**TOWN OF NEWBURGH  
PLANNING BOARD  
TECHNICAL REVIEW COMMENTS**

**PROJECT: CORTLAND COMMONS**  
**PROJECT NO.: 2017-11**  
**PROJECT LOCATION: SECTION 9, BLOCK 1, LOT 60**  
**REVIEW DATE: 10 MARCH 2017**  
**MEETING DATE: 16 MARCH 2017**  
**PROJECT REPRESENTATIVE: JMC PLANNING & ENGINEERING**

SP-1

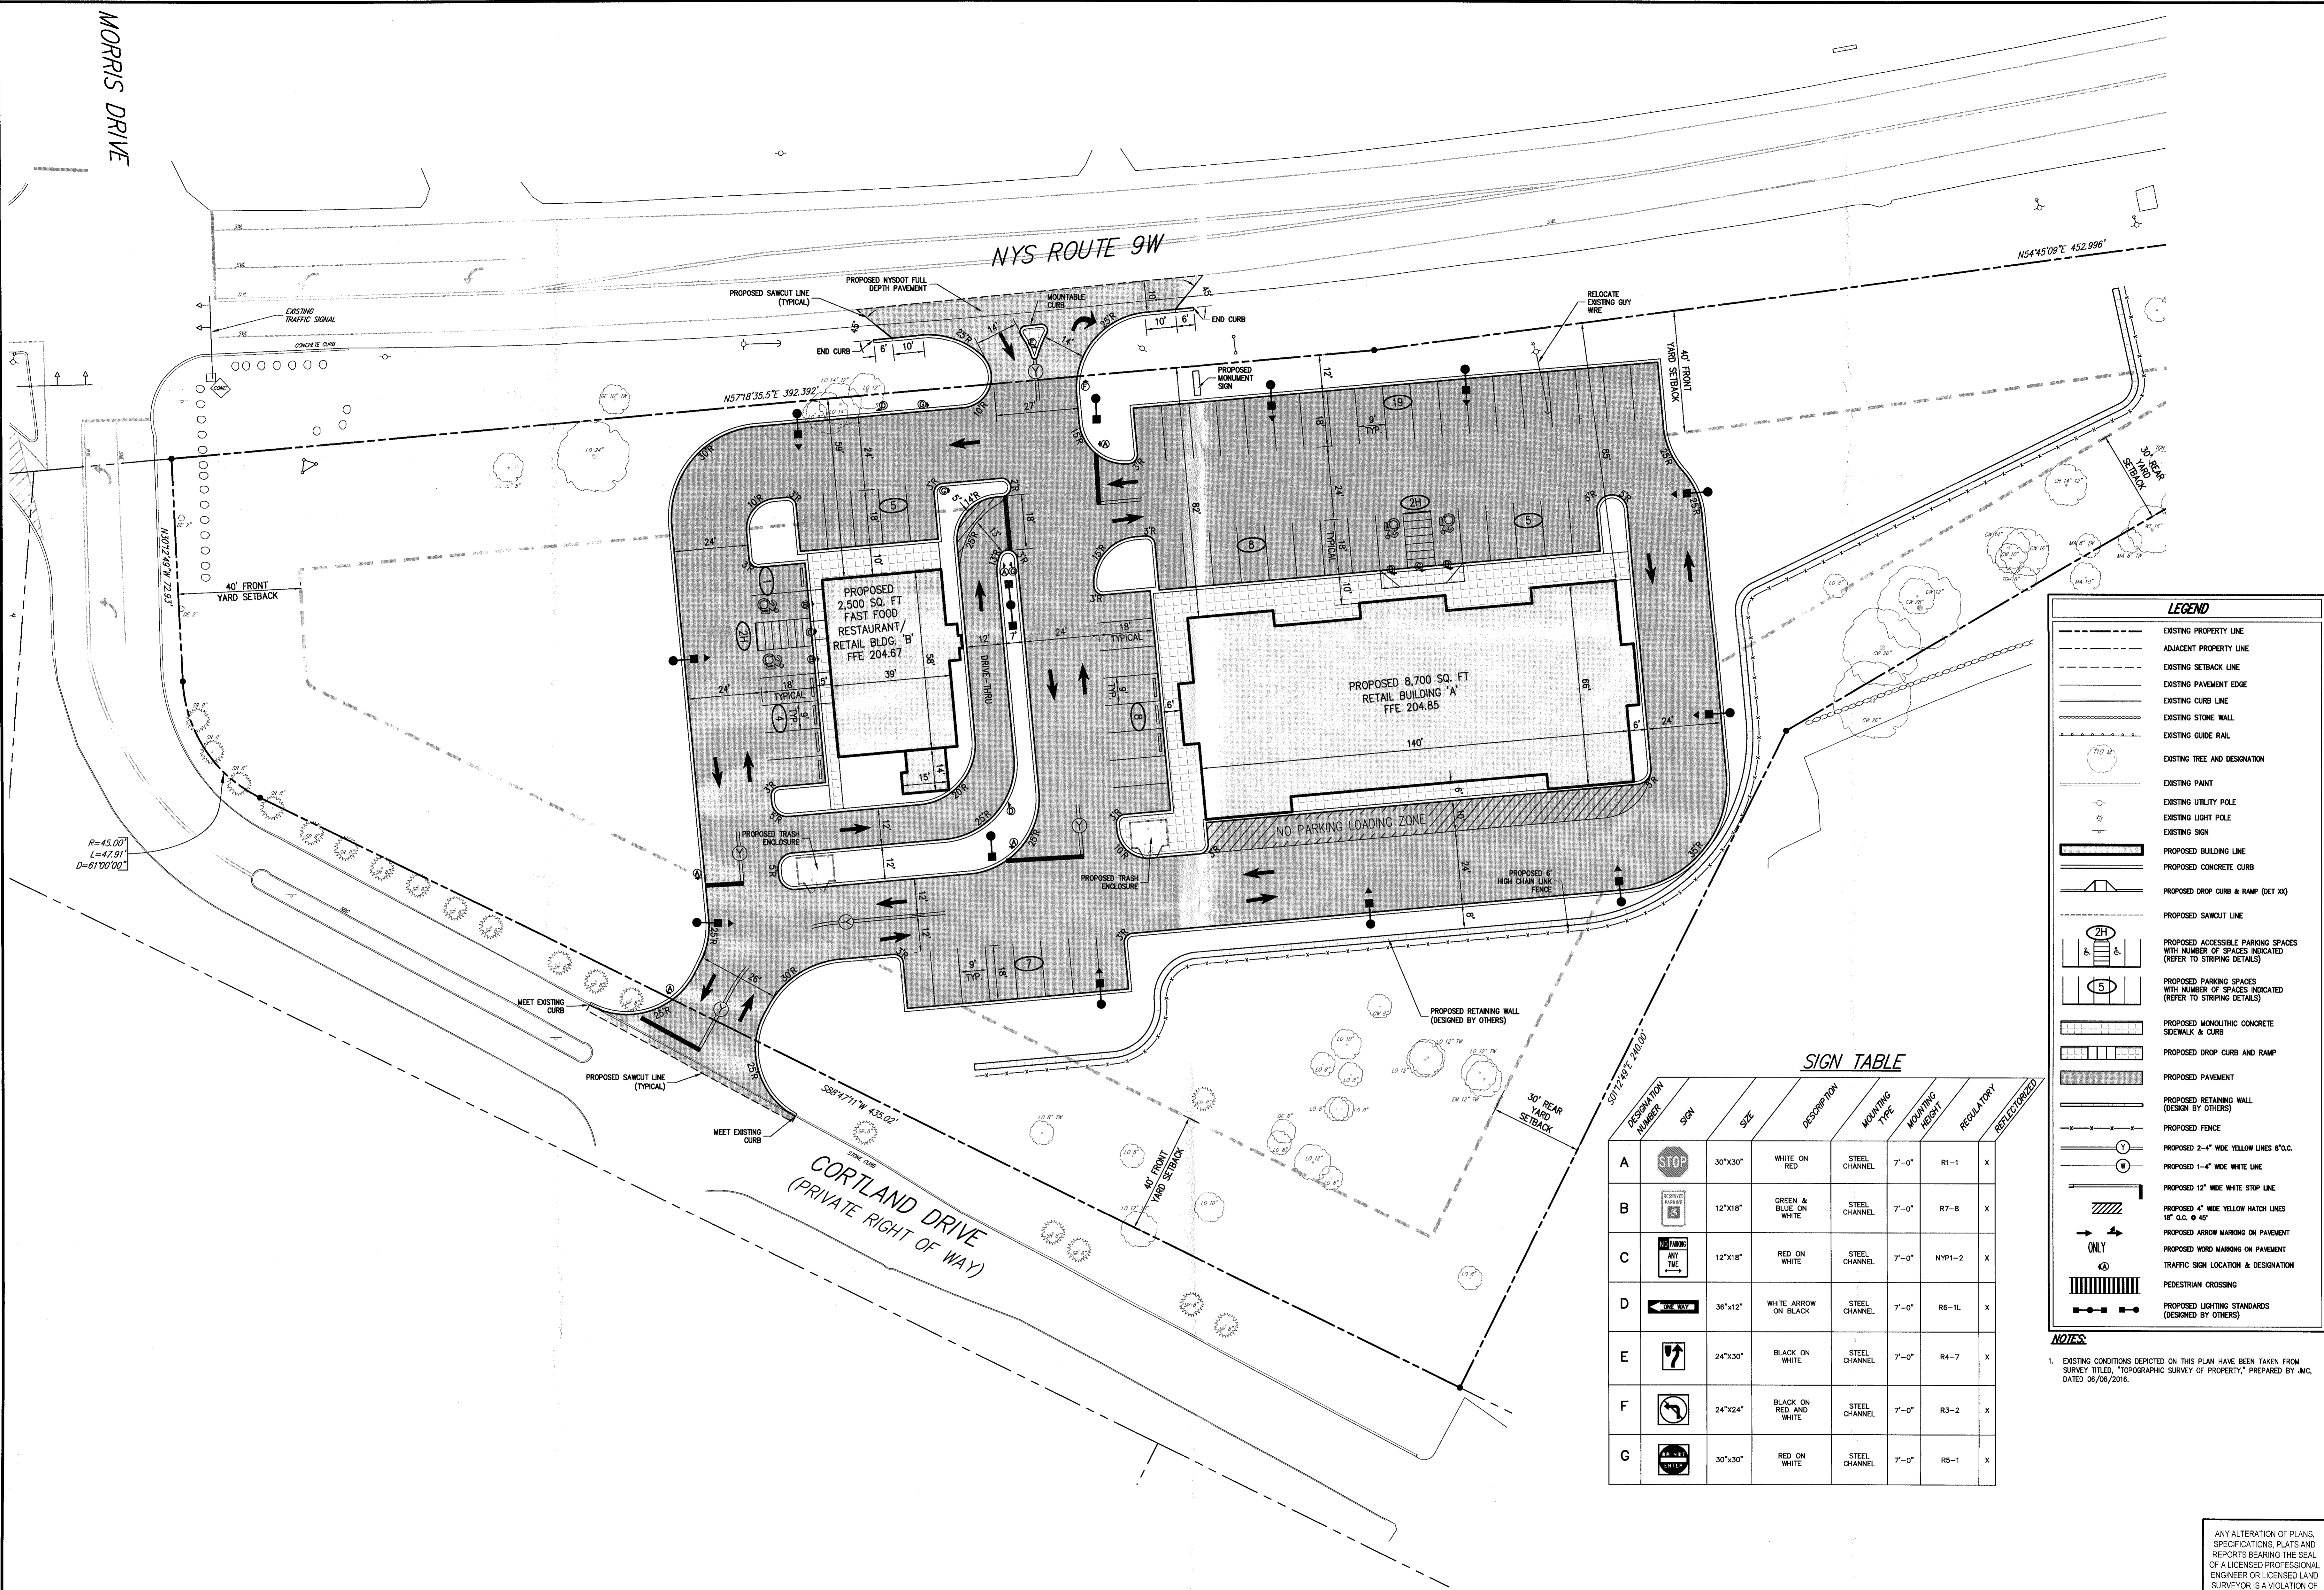
7. Lead Agency circulation should include NYSDEC, NYSDOT, Orange County Health Department as involved agencies.
8. The zoning Bulk Table on sheet SP1 identifies the front yard as 40 ft minimum and proposed 59. Section 185-18 –Exceptions to District Regulations(4)(b) requires front yards abutting all State and County Highways be at least 60 feet in depth.

9. The lots in the B Zone, which abut a Residential District, in this case R-3, require side yard setbacks of greater of the setback identified in the B Zone or 25 feet. Side yard setback should be identified as 25 feet rather than 15 as depicted in the table.

12. The Bulk Table parking summary identifies 63 xx parking spaces required while the parking calculation identifies 68 parking spaces required.
13. The Applicants representative is asked to check the additional parking spaces. Total spaces provided appears to be 61 including handicap spaces.

Drawn	RC	Approved	JS
Scale	1" = 20'		
Date	02/23/2017		
Project No.	16055		
MSB-SE	UTL	UTL	UTL
Drawn By	SP-5

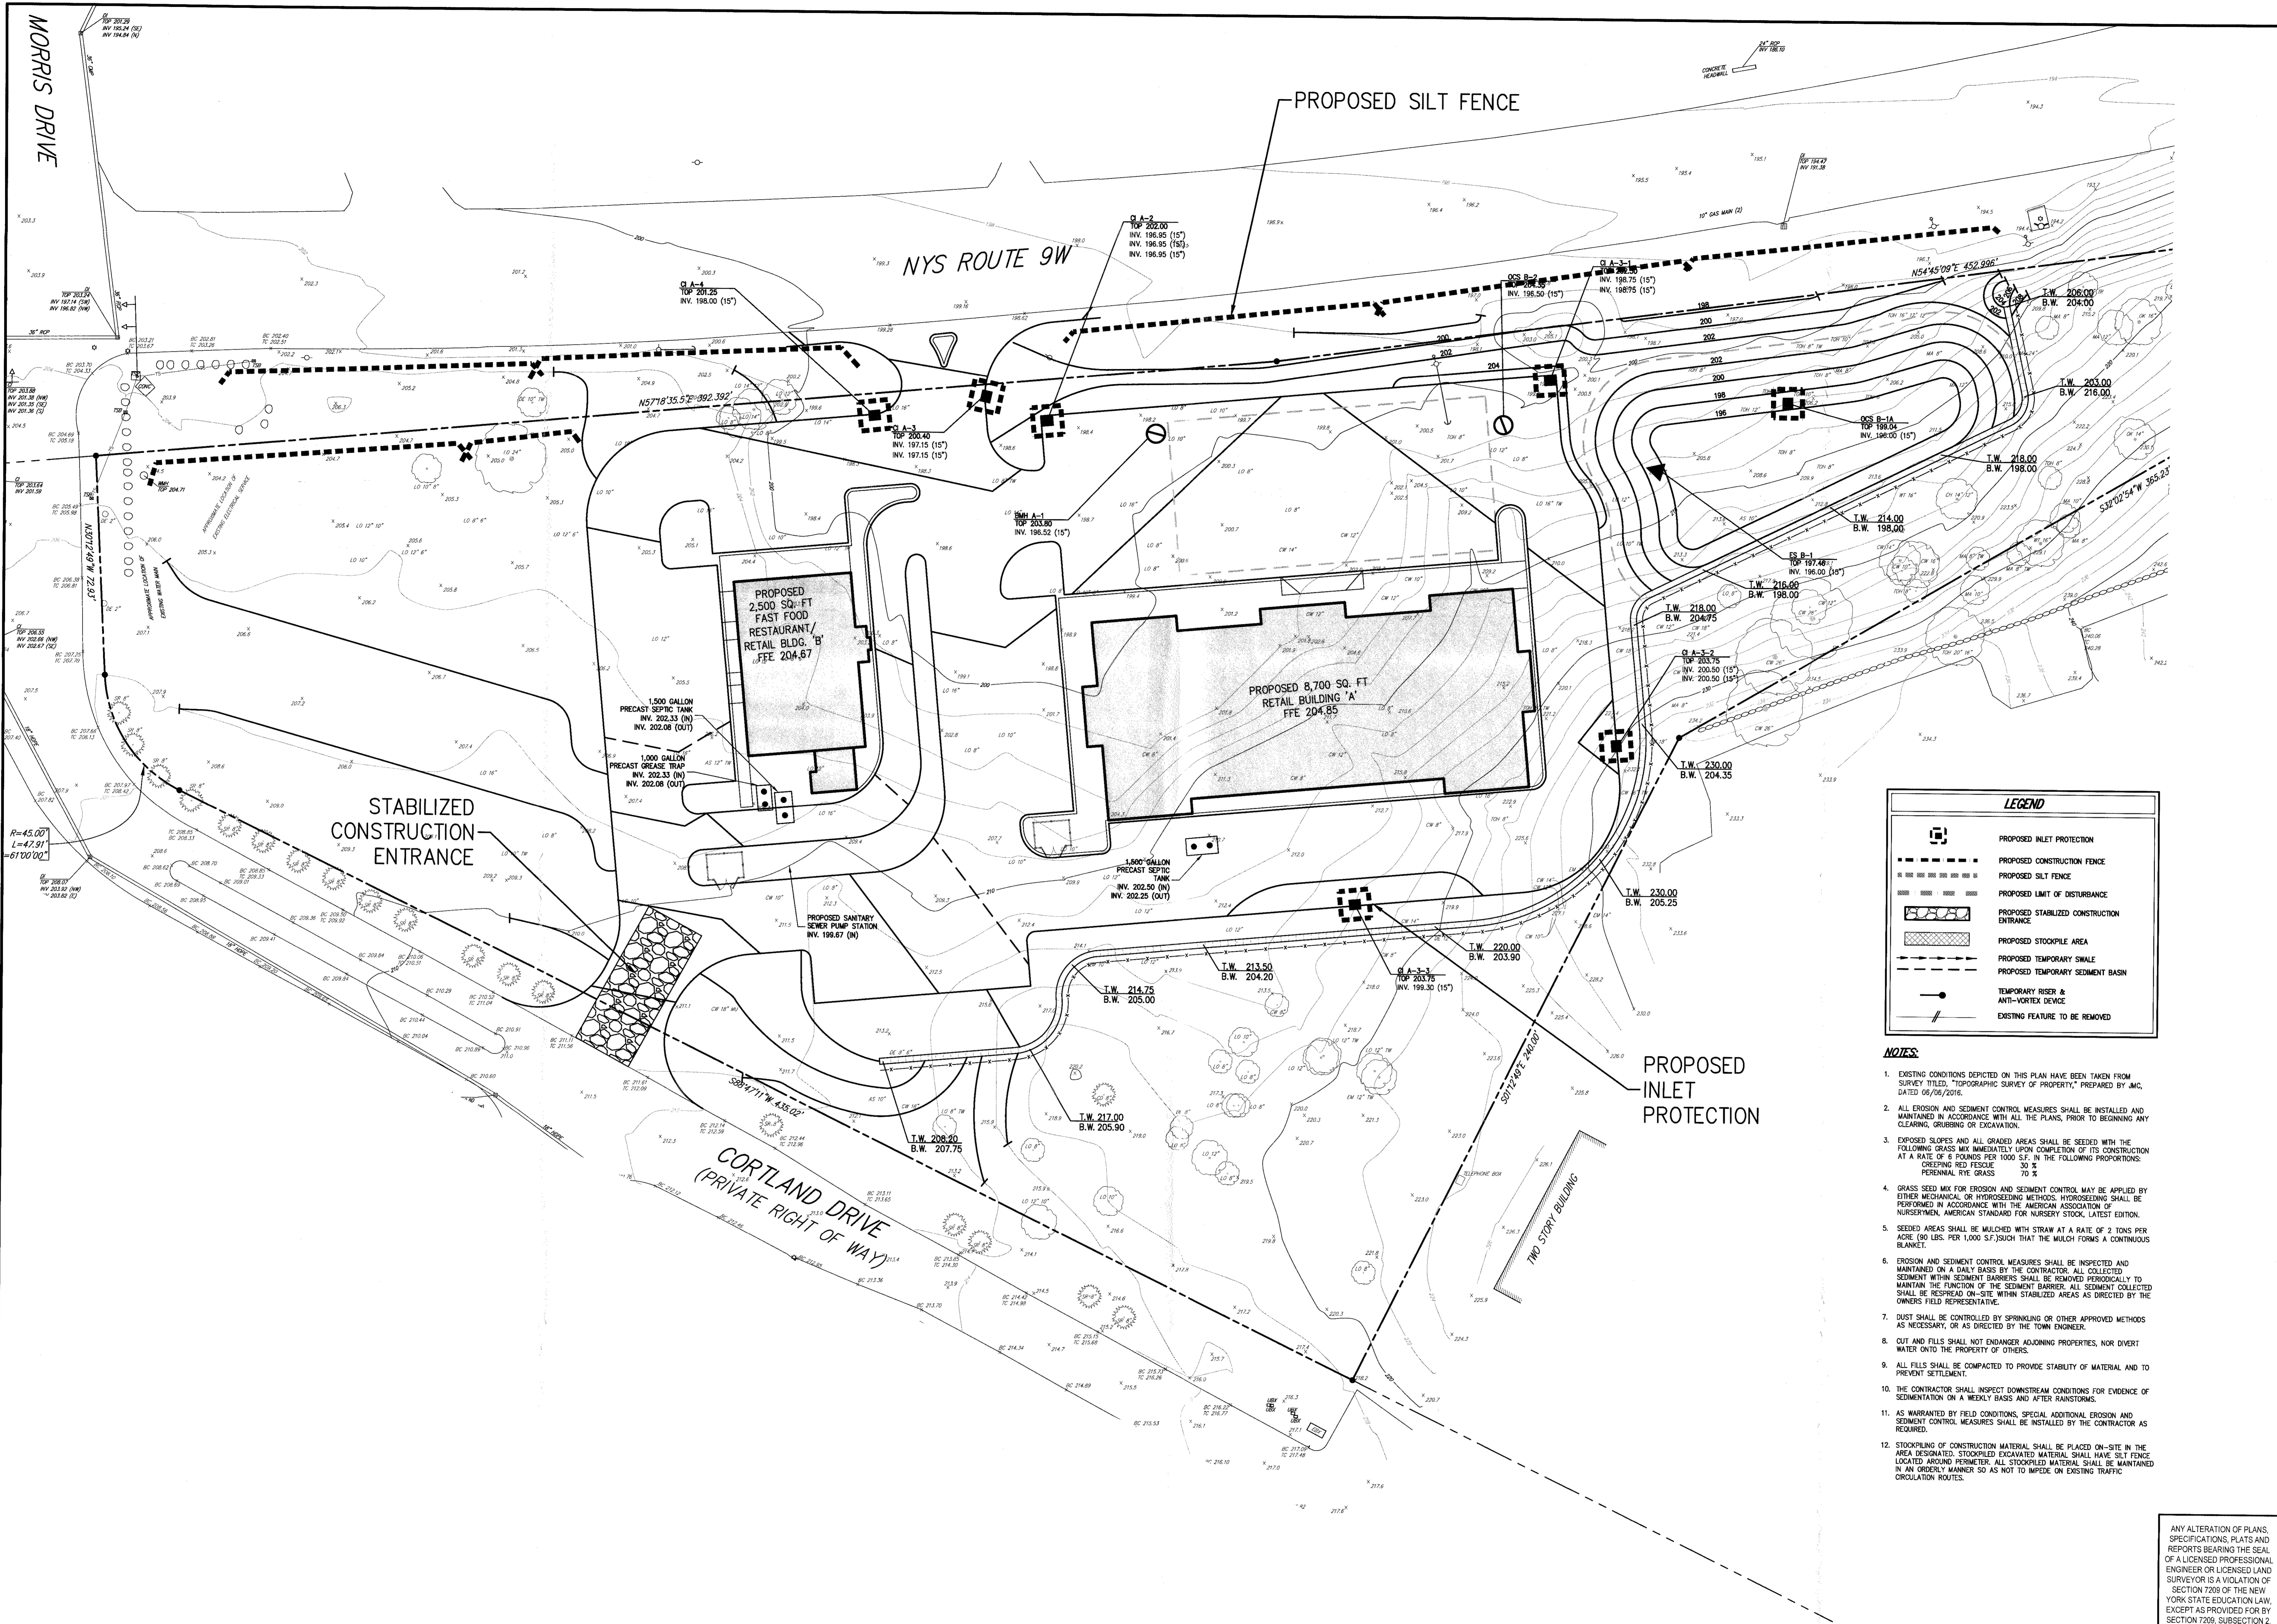
3. The constructability of the retaining wall in very close proximity to the property line should be addressed.
4. The septic design chart on sheet SP5 identifies flow rates for the project. Flows are identified as 25 gallons per day times 37 seat restaurant at 2,295. While the calculation should identify 925. The 2,295 is actual gallons per day from the entire site. The subsurface sanitary sewer disposal system design of 2,300 +/- gallons per day will require a SPDES permit from the DEC and review by the Orange County Health Department.
